UNITED STATES PATENT AND TRADEMARK OFFICE

APPLICATION NO.	FILING DATE	FIRST NAMED INVENTOR	ATTORNEY DOCKET NO.	CONFIRMATION NO.
10/763,044	01/22/2004	Olivier Pizzuto	02-RO-250	3798

Office Action Summary

DETAILED ACTION

FIG. 6

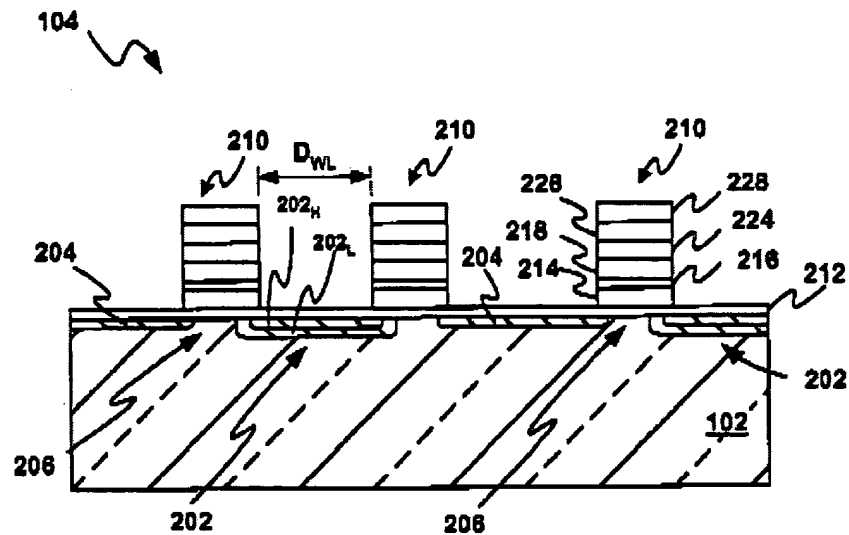
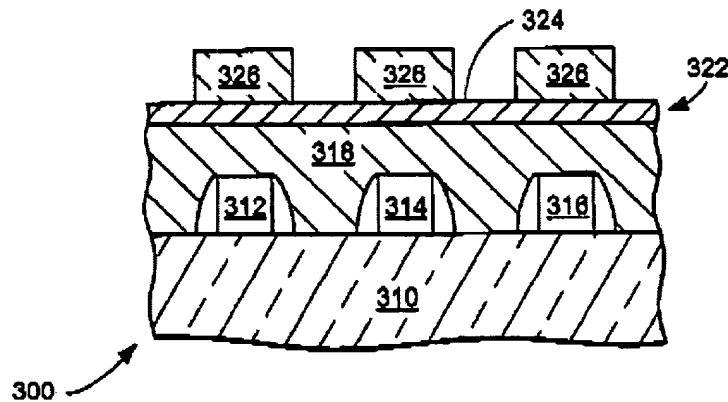
Subramanian discloses a method for flash memory process as claimed.

See all FIGS, where Subramanian teaches the following claims.

Pertaining to claim 1, Subramanian discloses a method for producing a flash memory comprising:

forming at least two adjacent rows of precursor stacks of floating gate transistors **214** on a semiconductor substrate **102**, with the precursor stacks **210** being at least partially covered by a protective resin **212 & 318** and being separated by a formation zone for a source line **202** ;

forming a trench **202** in the formation zone for the source line **202** by an attack of the formation zone and of the protective resin **212 & 318** so as to result in a deposit of residue from the protective resin below the precursor stacks **(Column 7 lines 26-29, please note the claim 1 directly refers to self-aligned source etching process)**;
